## **Boeing Australia Holdings response to ACMA Draft allocation and technical instruments for the 3.4/3.7 GHz bands auction**

Boeing Australia Holdings (Boeing Australia) appreciates the opportunity to respond to the ACMA consultation paper on the 'Draft allocation and technical instruments for the 3.4/3.7 GHz bands auction.'

Our response is specifically to the implications of protecting aircraft radio altimeter operations in the frequency band 4 200-4 400 MHz from interference from new wireless broadband (WBB)/5G applications operating in the nearby frequency range including the 3.4/3.7 GHz frequency under discussion in this consultation.

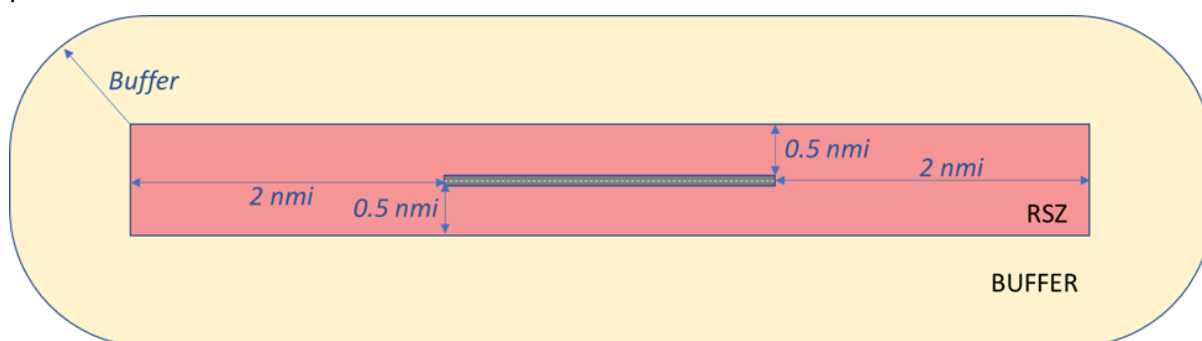
Boeing Australia recommends that 5G base stations transmitting up to 62 or 65 dBm/MHz in the 3.4-3.8 GHz frequency range be activated such that the limit of -49 dBW/m<sup>2</sup>/MHz is not exceeded in the runway safety zone (RSZ) at all runways where the current fleet of non -Group 4 radio altimeter equipped large airplanes operate.

To accomplish this, Boeing recommends not activating 5G base stations in the RSZ or within a buffer distance from the RSZ, as illustrated below, where the buffer size depends on maximum transmitted power as detailed in the table below. This approach would also likely cover all surface taxi and gate areas where radio altimeters must operate normally to avoid disruption to operations because airborne radio altimeter tolerances require larger separation distances.
